No. 2360  
ATA Code 53-10  
Recurring Inspection

**SUBJECT:** FUSELAGE - WING FORWARD SPAR CARRY-THRU STRUCTURE INSPECTION AND/OR REINFORCEMENT

BD-764 M

**Service Bulletin No. 2360**

Inspection for Cracks in the Wing Forward Spar Carry-Thru  
Figure 1

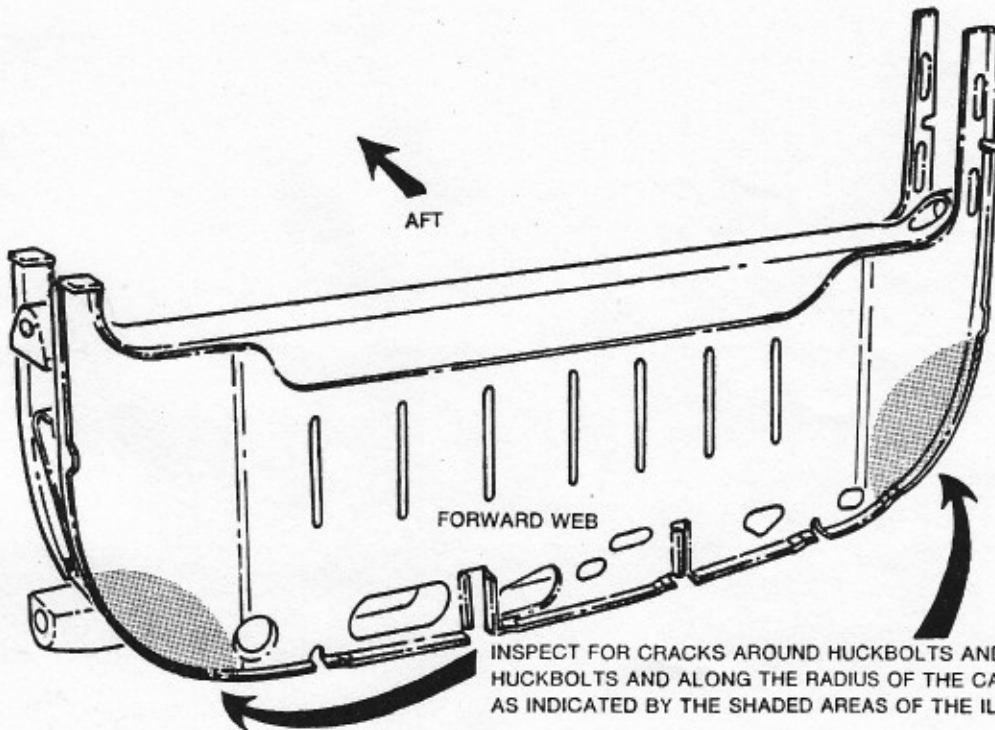
INSPECT FOR CRACKS AROUND HUCKBOLTS AND BETWEEN HUCKBOLTS AND ALONG THE RADIUS OF THE CARRY-THRU WEB AS INDICATED BY THE SHADED AREAS OF THE ILLUSTRATION

INSPECT FOR CRACKS AROUND HUCKBOLTS AND BETWEEN HUCKBOLTS AND ALONG THE RADIUS OF THE CARRY-THRU WEB AS INDICATED BY THE SHADED AREAS OF THE ILLUSTRATION

The first inspection must be performed no later than the first 1500 flight hours. If an airplane has over 1500 flight hours, the inspection is to be accomplished at the next scheduled inspection. If no cracks are found repeat the inspection every 500 hours.

Any of the areas shown in Figure 1 that are modified by the installation of a doubler need not be dye-penetrant inspected until 1500 flight hours after the installation of that particular doubler. If no cracks are found, repeat the inspection every 500 flight hours.

Areas shown in Figure 1 that have cracks that fall within allowable limits and that have not been modified by a doubler must be inspected or repaired as indicated in this Service Bulletin on an individual basis.

1) A crack up to 2.25 inches in length must be stop drilled #30 at crack ends and inspected for progression at each annual inspection or every 200 hours, whichever occurs first. One stop drilled crack per left side and one stop drilled crack per right side of the wing forward spar carry-thru structure bend radius are permissible, if neither one exceeds 2.25 inches.

2) A crack between 2.25 inches and 4.0 inches in length shall be stop drilled #30 at crack ends. The area is to be repaired per the applicable P/N 36-4004 Kit within the next 100 flight hours.

3) A crack exceeding 4.0 inches in length shall be repaired prior to further flight per the applicable P/N 36-4004 Kit.

1) A crack less than 1.0 inch in length or one crack between two fasteners does not require immediate repair, but shall be inspected for progression at each annual inspection or every 200 hours, whichever occurs first. A crack emanating from one fastener in two directions is considered to be one crack. **Do not stop drill, due to the possibility of damaging structure behind web face.** One crack per left side and one crack per right side of the wing forward spar carry-thru structure web face are allowed, if neither one exceeds 1.0 inch.

2) A crack more than 1.0 inch in length shall be repaired per the applicable P/N 36-4004 kit, within the next 25 flight hours.

A crack which passes through two fasteners but is less than 0.5 inch beyond either fastener shall be repaired per the applicable P/N 36-4004 kit within the next 25 flight hours.

3) A crack passing through two fasteners and extending beyond for more than 0.5 inch on either end shall be repaired prior to further flight, per the applicable P/N 36-4004 kit.

c. A combination of the cracks described in Steps "a" and "b" is acceptable. If cracks are found in both the forward and aft web face and/or the bend radius on the same side of the airplane, and any of the cracks are more than 1.0 inch long, a repair shall be made prior to further flight.
